Product Change Notice

Transceiver	
AFBR-57E6APZ	AFBR-57E6APZ-EN1
AFBR-57E6APZC	AFBR-57E6APZ-EX1
AFBR-57E6APZ-HT	AFBR-57E6APZ-EX2

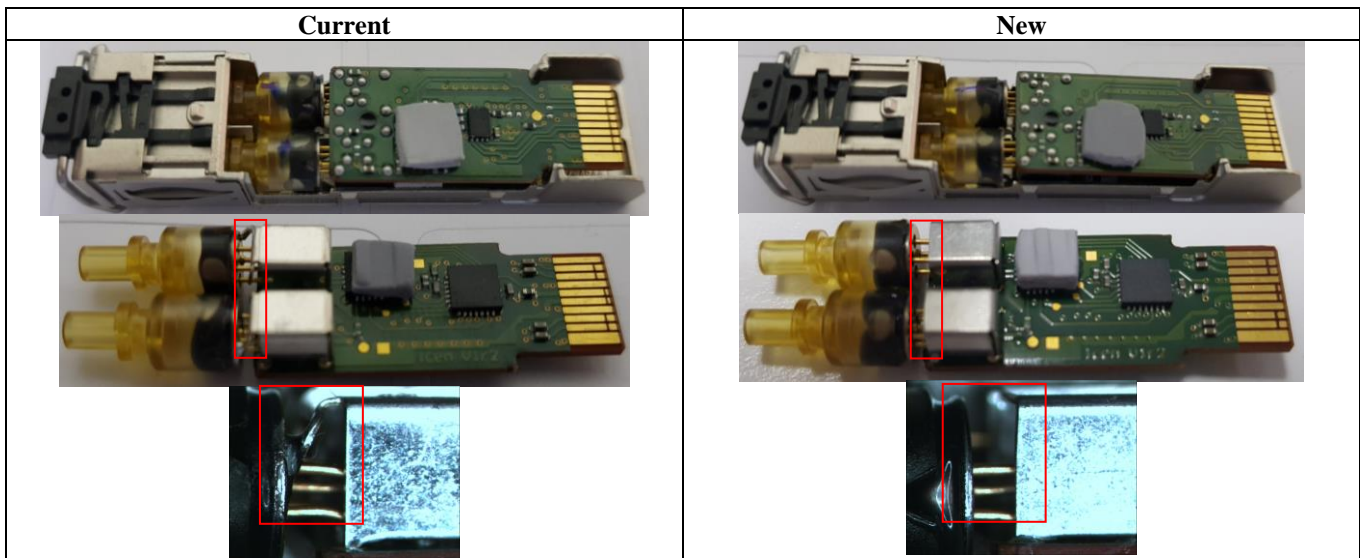
1. Use simplified EMI shield in production.

Boxed in red: Current EMI shield has two horns while simplified EMI shield has horns removed.

1. Eliminate EMI horns to increase the distance between optical subassembly leads to the EMI shield to improve product DC isolation.

The product datasheet specification, EMI and ESD performance remains the same.
